Gateway documentation:
Stage 2 DEVELOP & ASSESS

Step 2A Airspace Change Design Options
and
Design Principles Evaluation

ACP – 2023 - 022

Option 2.

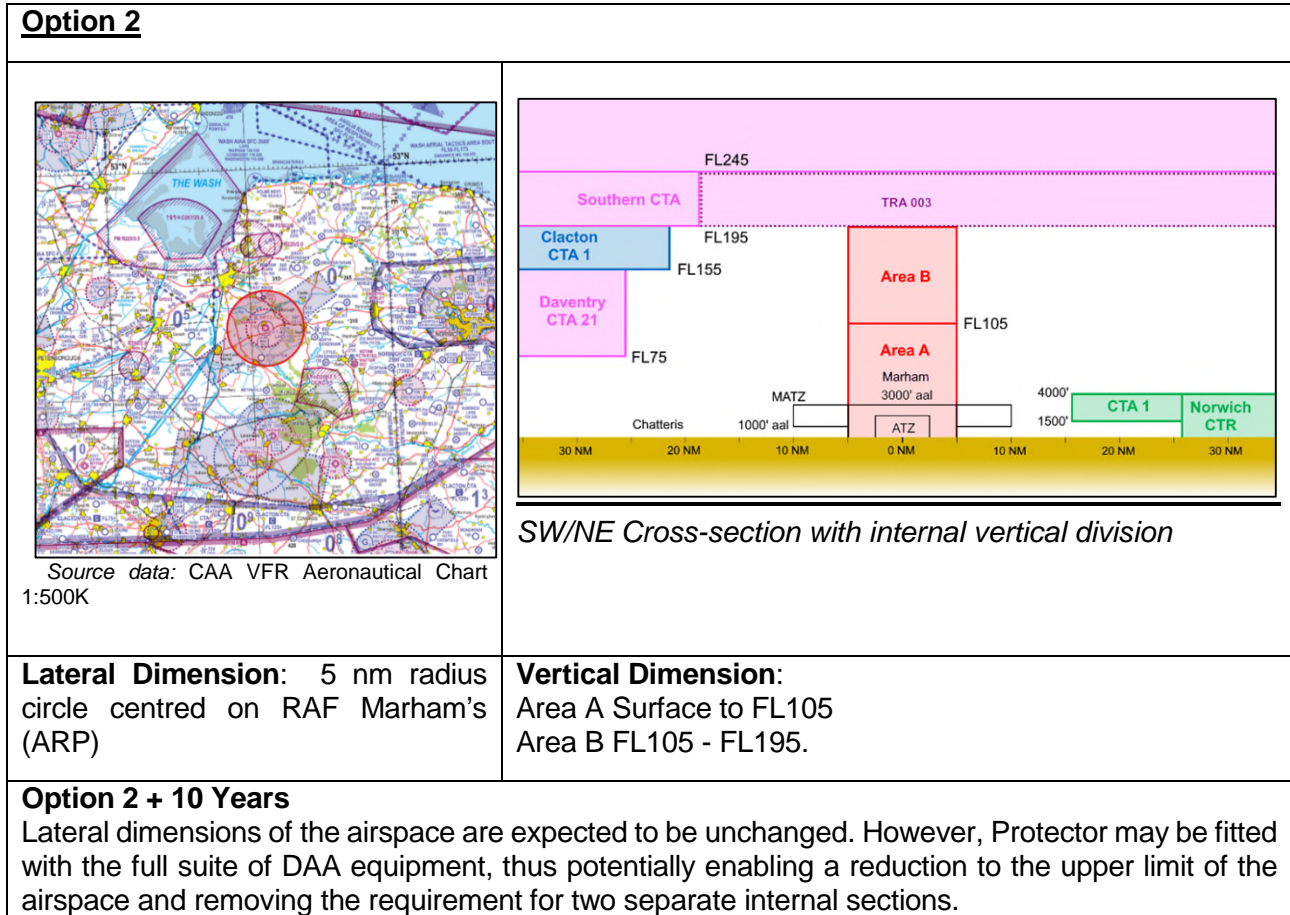
Height of vertical division in Option 2	Stakeholders suggested consideration is given to the division height: Lower height to increase capacity for GA transits; Higher height to accommodate F-35B practice flame out procedures in the lower section whilst Protector holds in the section above; Potential for a 3-tiered area rather than 2.	The airspace trial scheduled for Summer 2024 will provide an indication of the typical duration for Protector's occupation of Areas A & B. The Change Sponsor recognises the balance to be struck between hold times for civil aircraft versus operational ability for military aircraft. To ensure all airspace user requirements are considered, the internal division of the airspace construct will be a topic for further engagement at Stage 3 of the ACP.
Additional Feedback	2 non-aviation stakeholders felt they did not have the expertise to comment on the ACP.	Change Sponsor has produced a 'jargon free' overview, together with FAQs, to be made available to stakeholders at Stage 3, Consult.

Based on the DP Evaluation and stakeholder feedback received, the Change Sponsor has decided Option 1 will be discounted and only Option 2 will be taken through to the Options Appraisal.
